Hummingbird Energy LLC
Second Set of Supplemental Responses to Siting Board Staff's First Request for Information
Case No. 2022-00272

HUMMINGBIRD SOLAR PROJECT

Title
CONCEPTUAL LAYOUT
OVERALL SITE

Project No. 193708901	Scale NTS
Revision Sheet E	Drawing No. C200
2 of 5

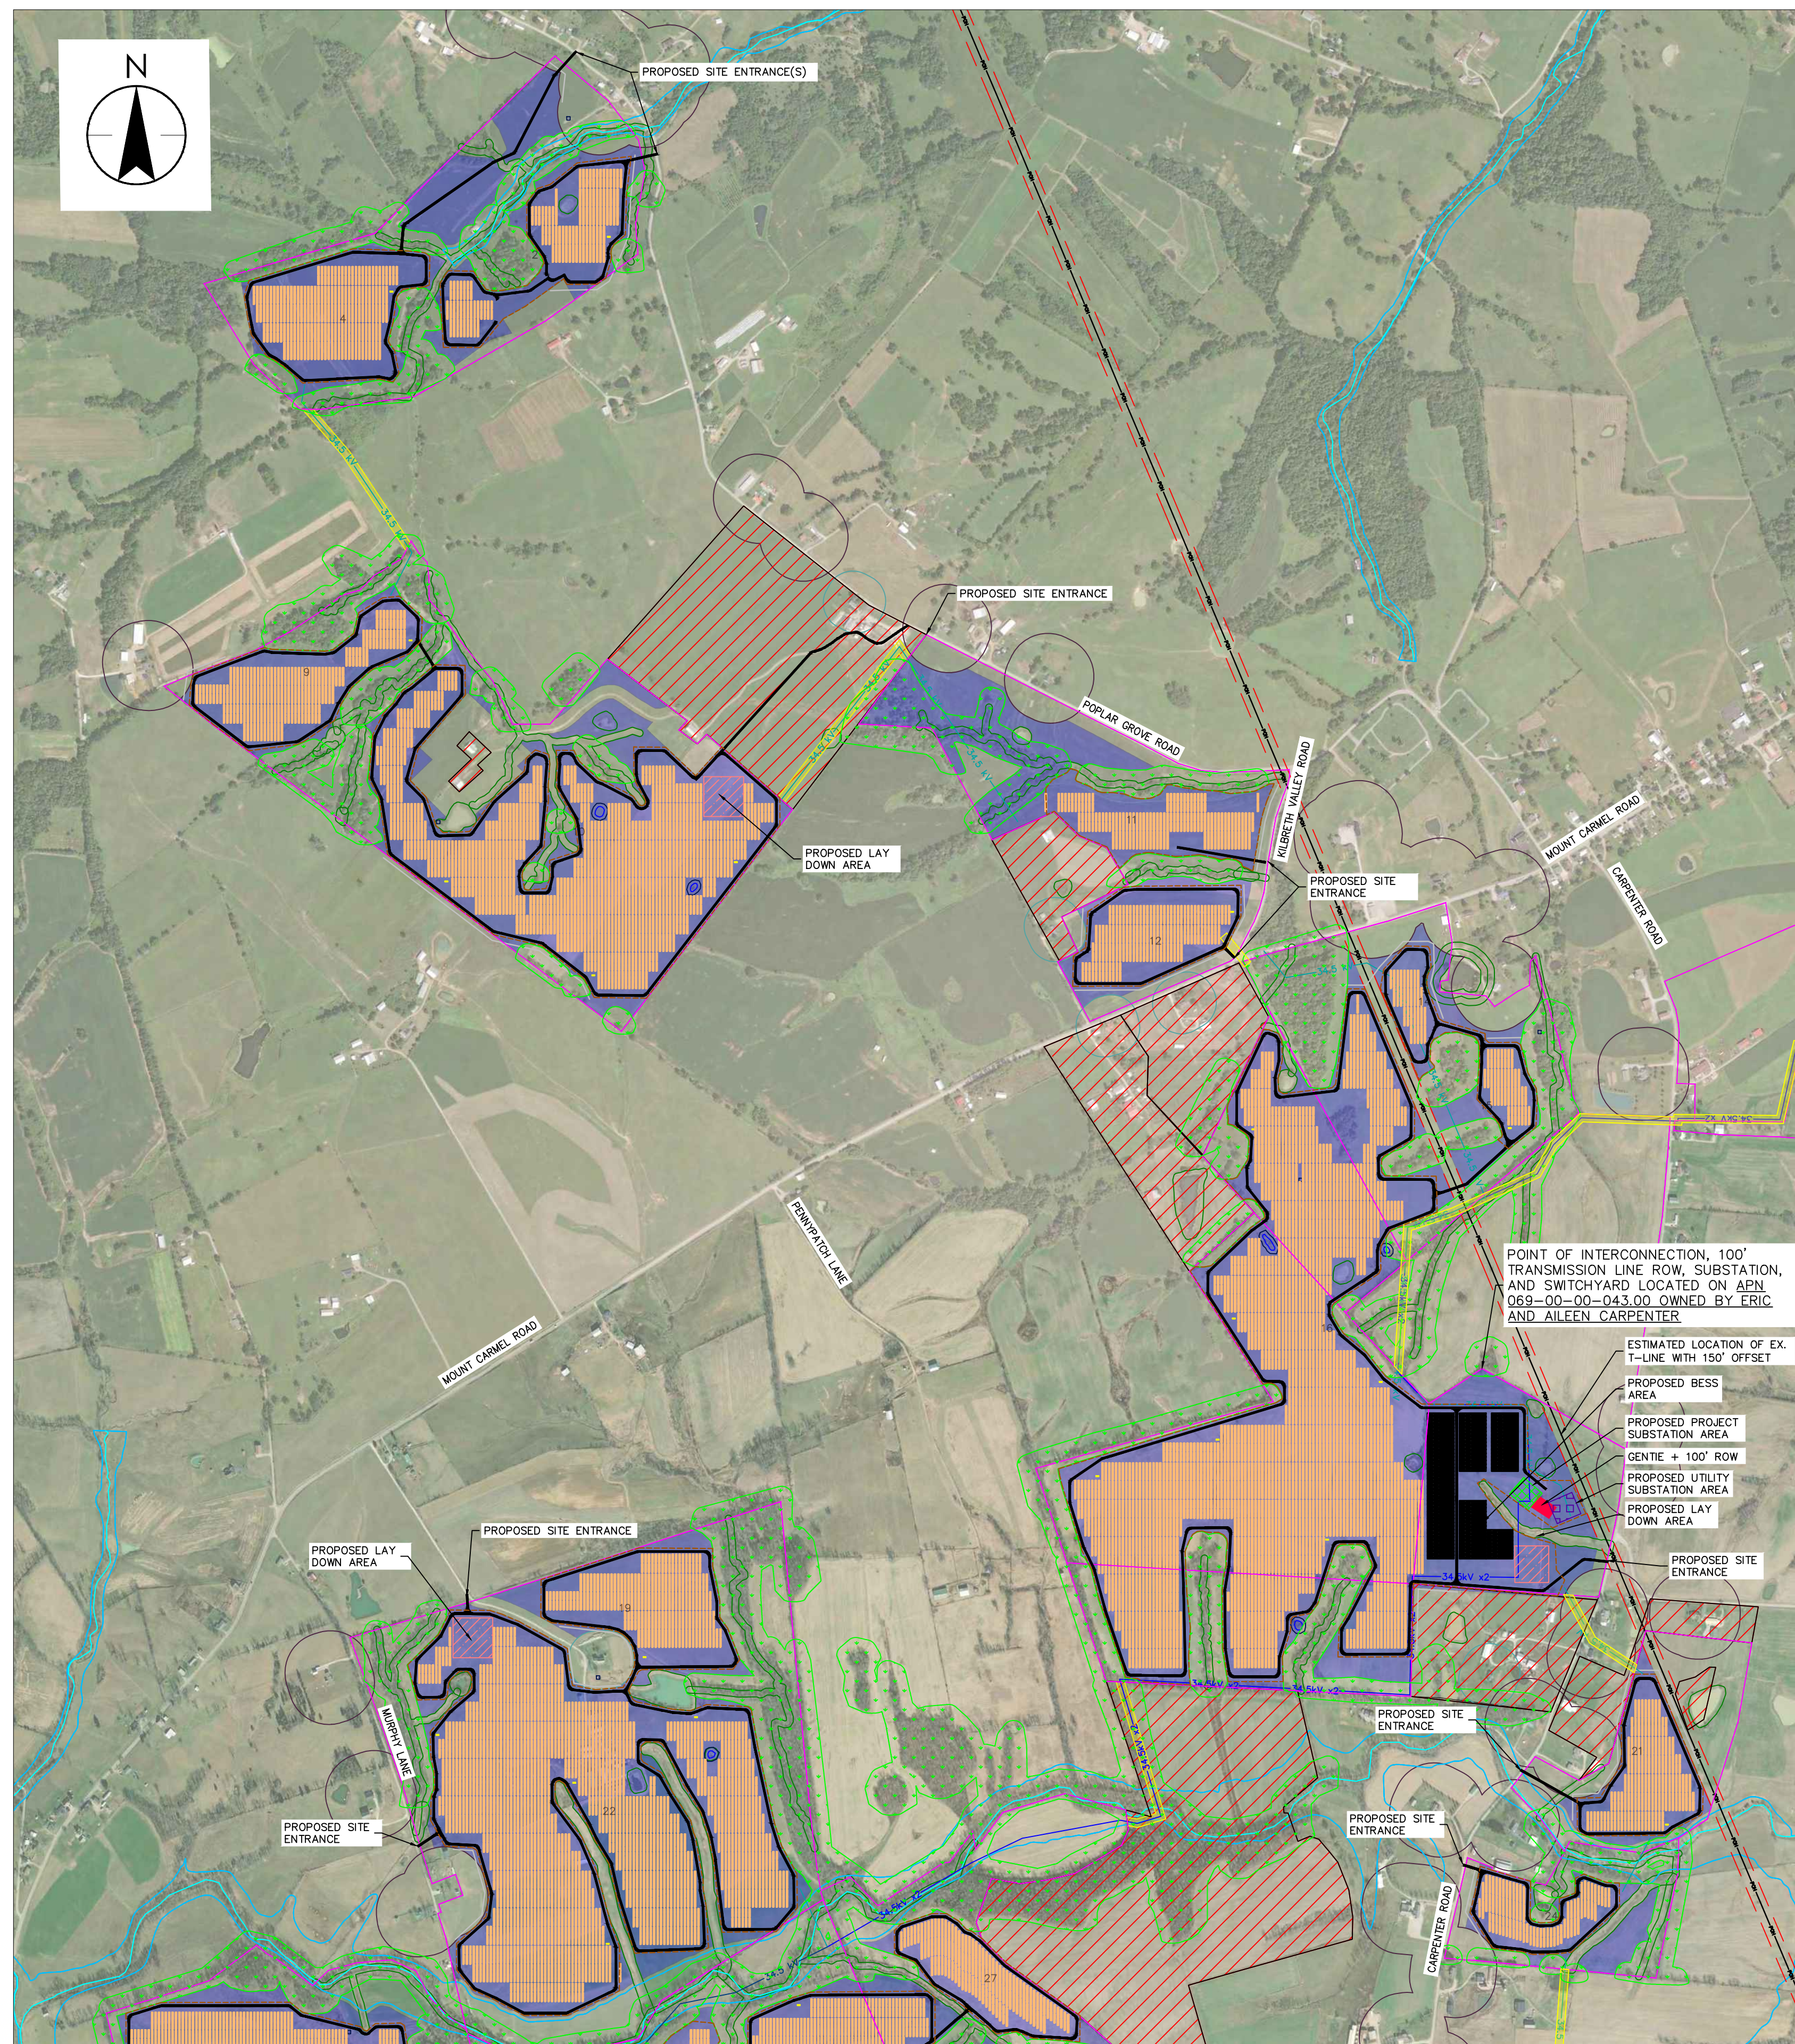
List of Changes to C200-2

- Labels added for two proposed site entrances.
- Label proposed site entrance for the access road extended to touch Poplar Grove Road.

- MV feeder line near POI reconfigured so as to not travel parallel with overhead T-Line.
- Arrows updated to point to access roads, not thoroughfares.
- Label for proposed site entrance added near Murphy Lane.

Revision Sheet
E 3 of 5

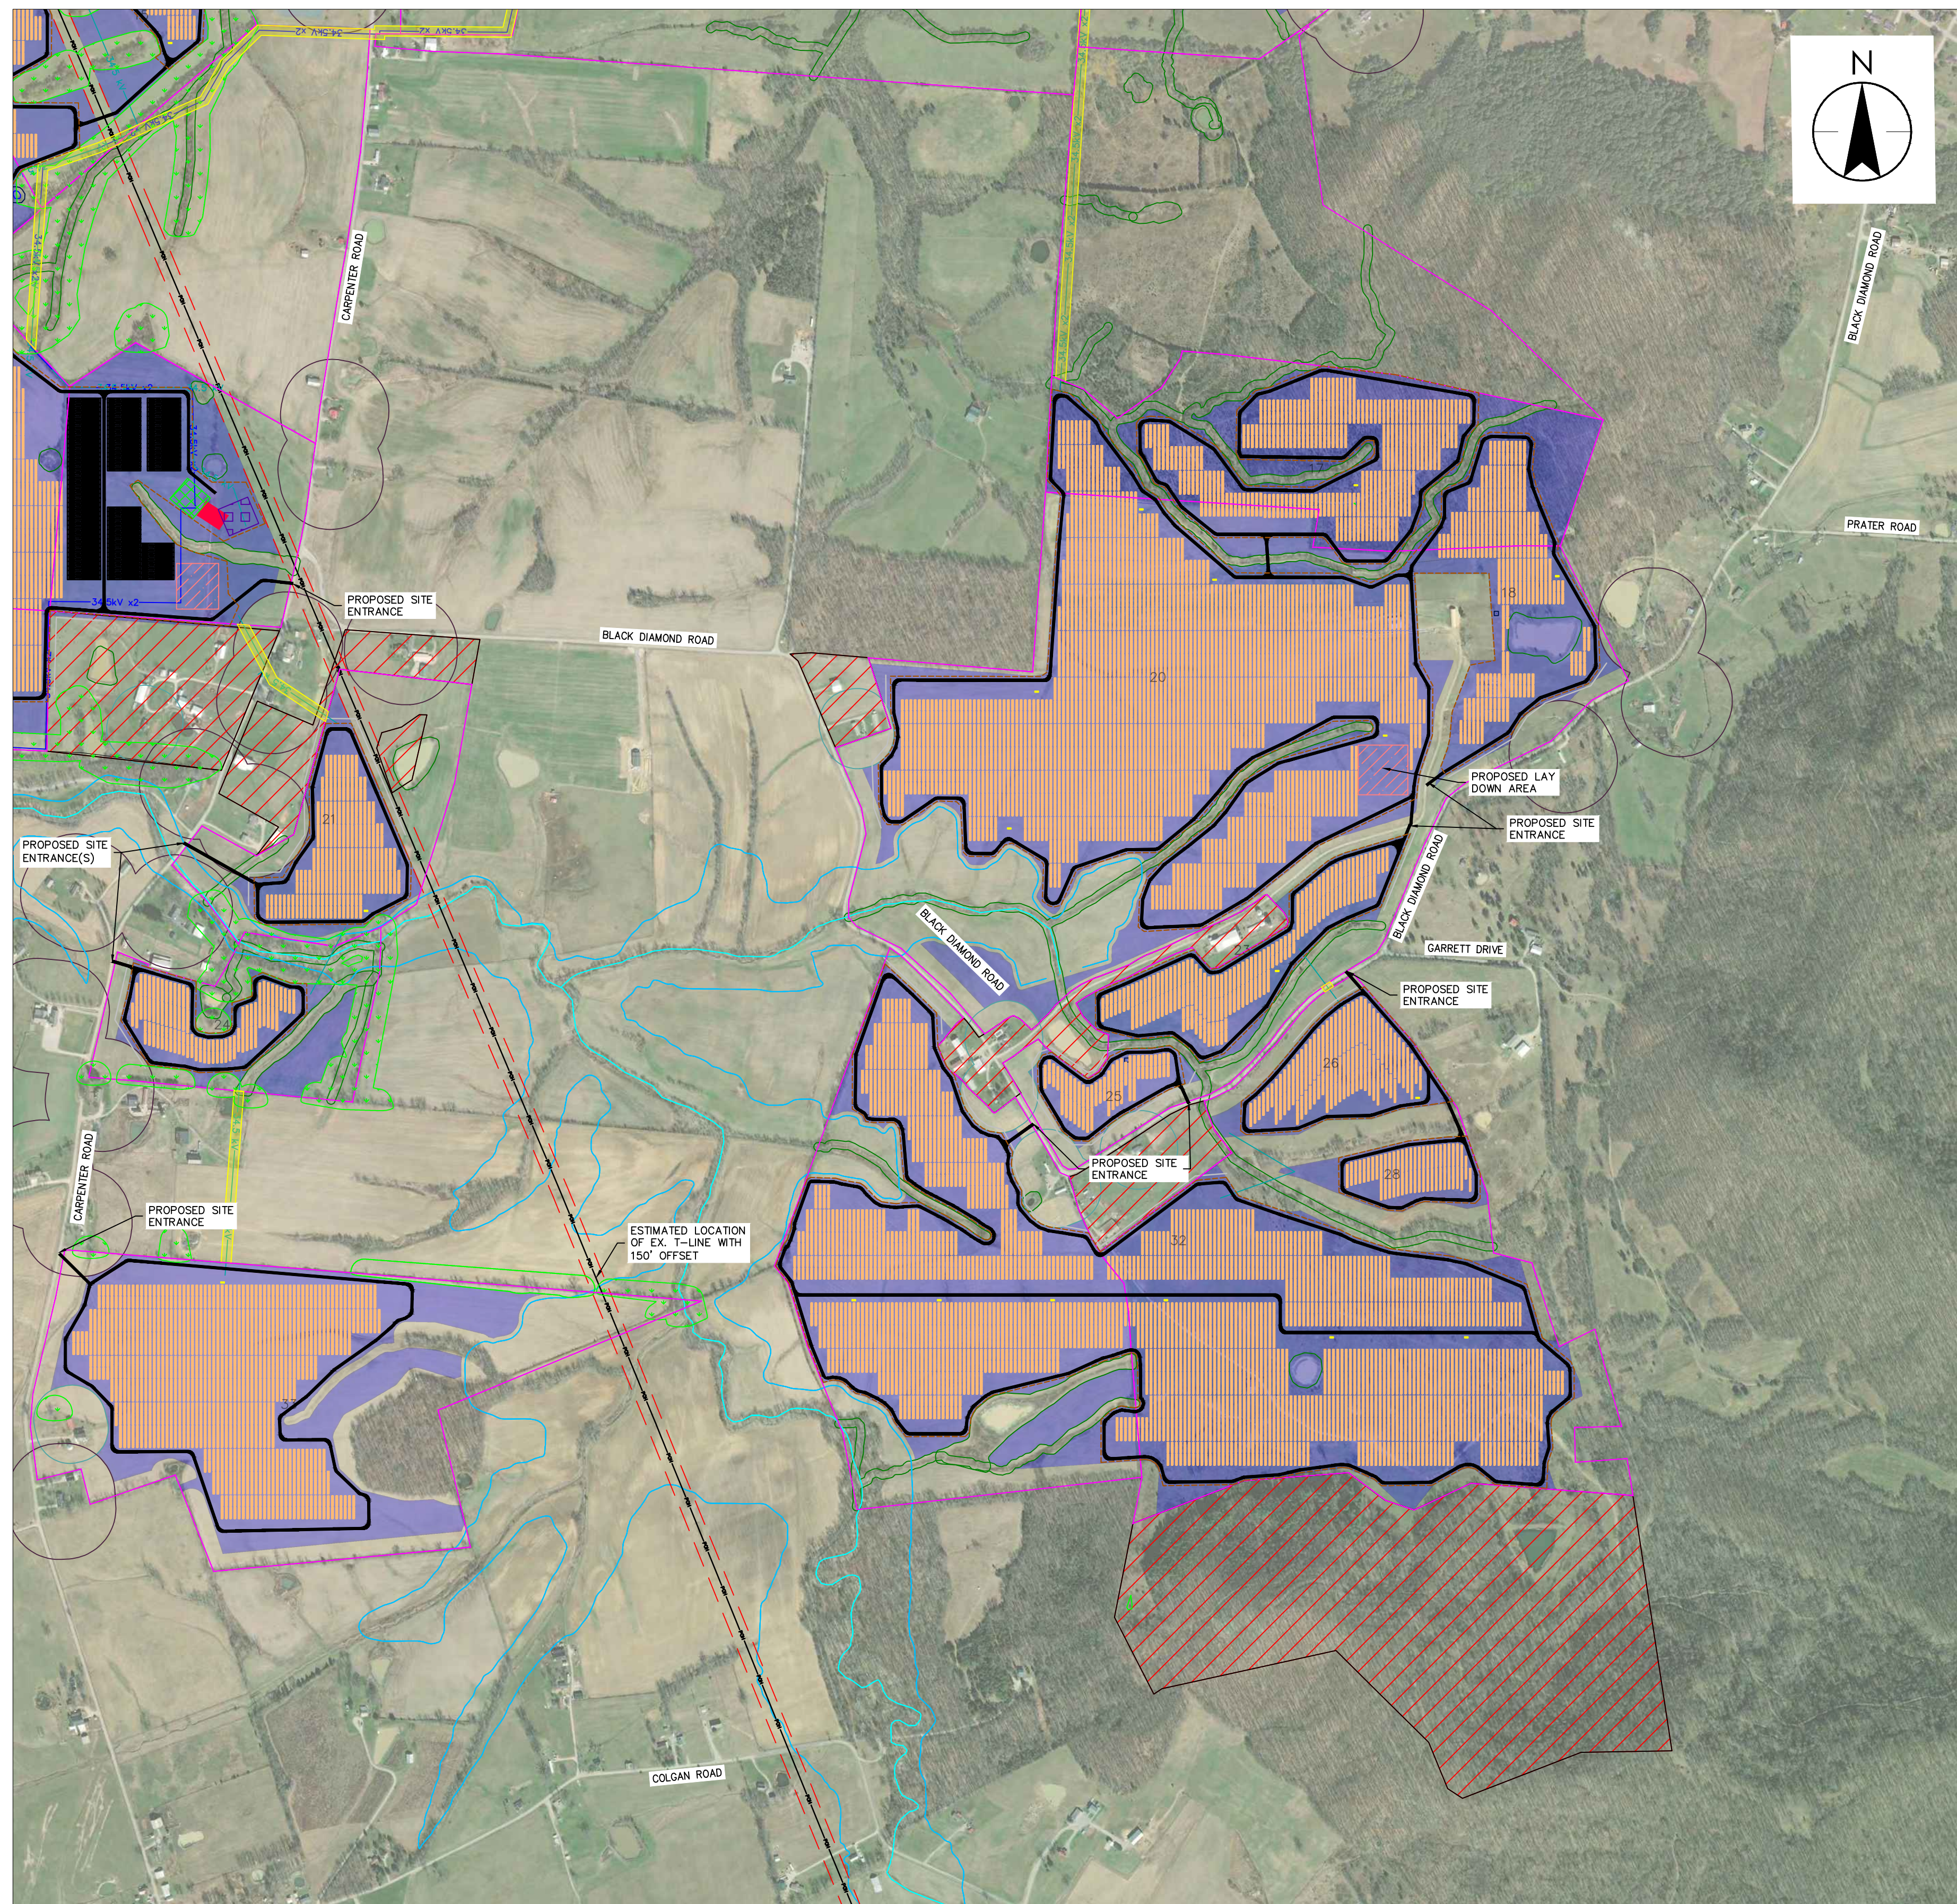
List of Changes to C200-3

- Labels for 3 proposed site entrances added, with entrance roads added which stretch to Carpenter Road.
- MV feeder line near POI reconfigured so as to not travel parallel with overhead T-Line.

Revision Sheet
E 4 of 5

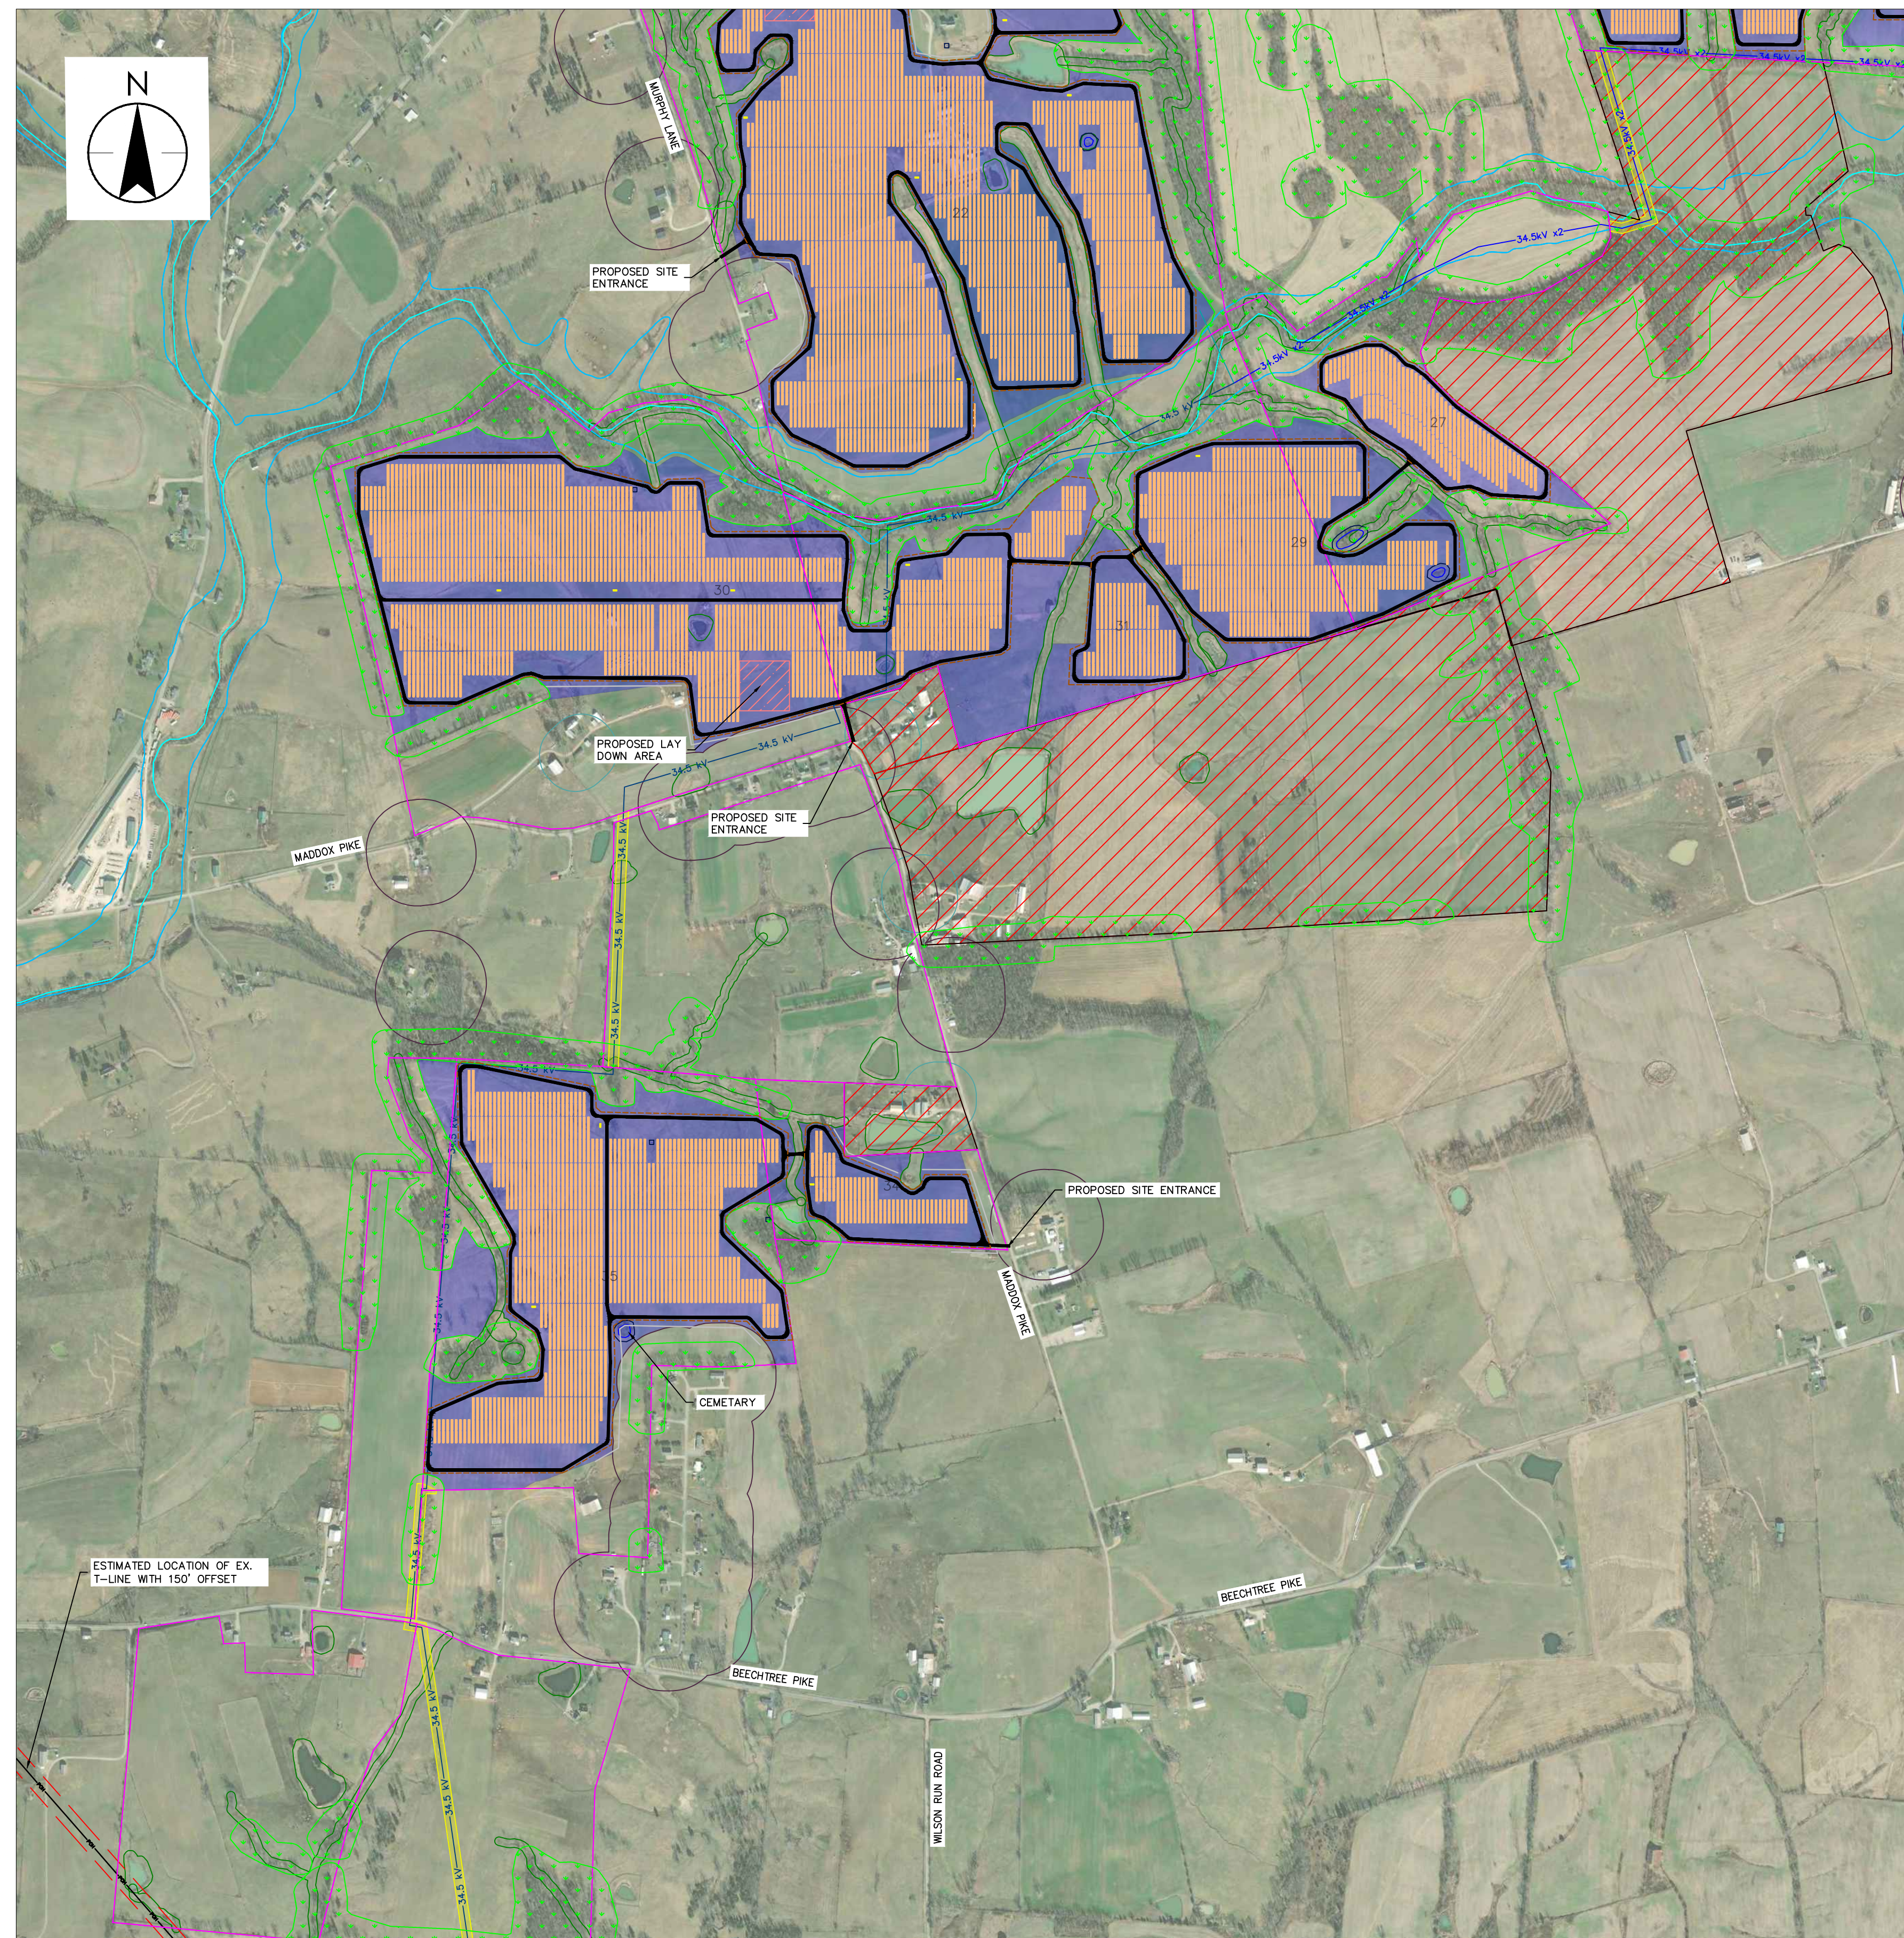
List of Changes to C200-4

- Label added for proposed entrance road.
- Karst feature relabeled as cemetery with label added.
